DA Stage BCA Assessment Report

71-75 Victoria Road, Drummoyne

Reference No: 112298-BCA-r2

Client: PBD Architects

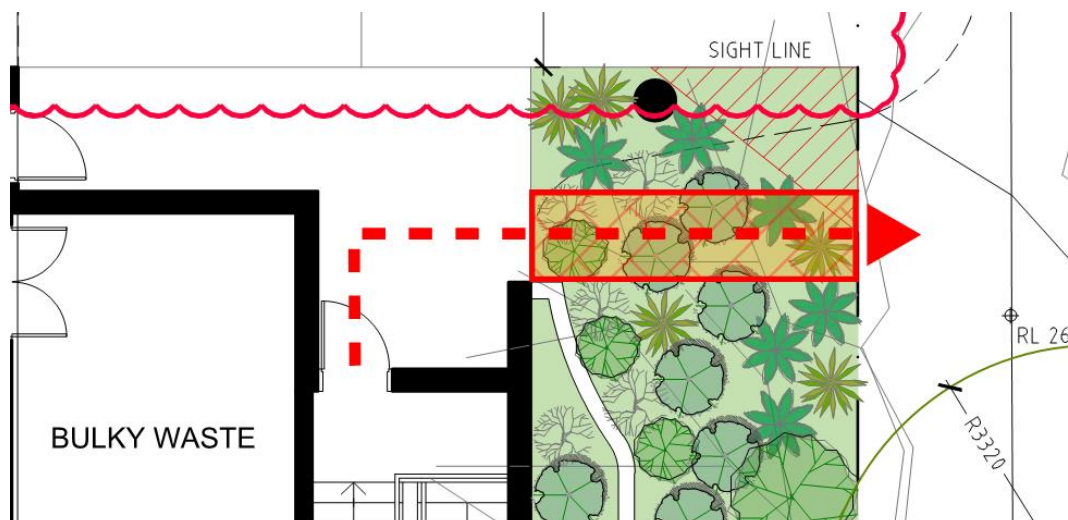
- 3.1.1. Provide internal protection to the Retail 1 and Retail 2 glazing perpendicular to the discharge of FS-1 in accordance with BCA C3.4 to meet the requirements of BCA D1.7(c).

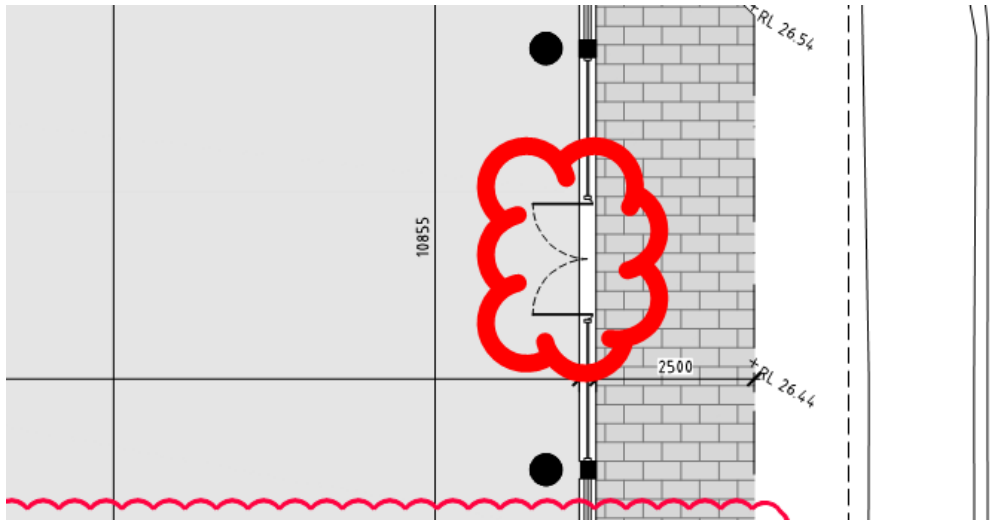
- 3.1.2. Provide a 1m clear width hard-surface path of travel from the discharge of FS-2 to Day Street as shown below. Note this is to avoid exposure of the path of travel to the loading area roller shutter which would then trigger the need to protect this shutter for the purposes of BCA D1.7.

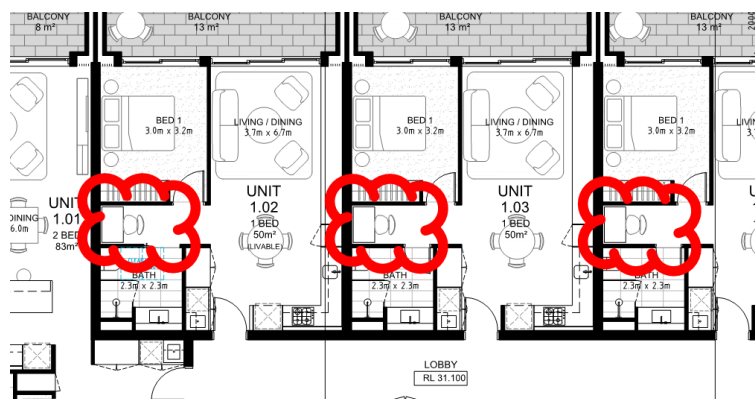
3.1.4. Confirm the proposed use and combined maximum population number within Retail 1 and Retail 2 on Ground Floor level. Note if the combined occupation number is to exceed twenty (20) patrons and the use is food & beverage then sanitary facilities will need to be provided to meet BCA F2.3 and Table F2.3.
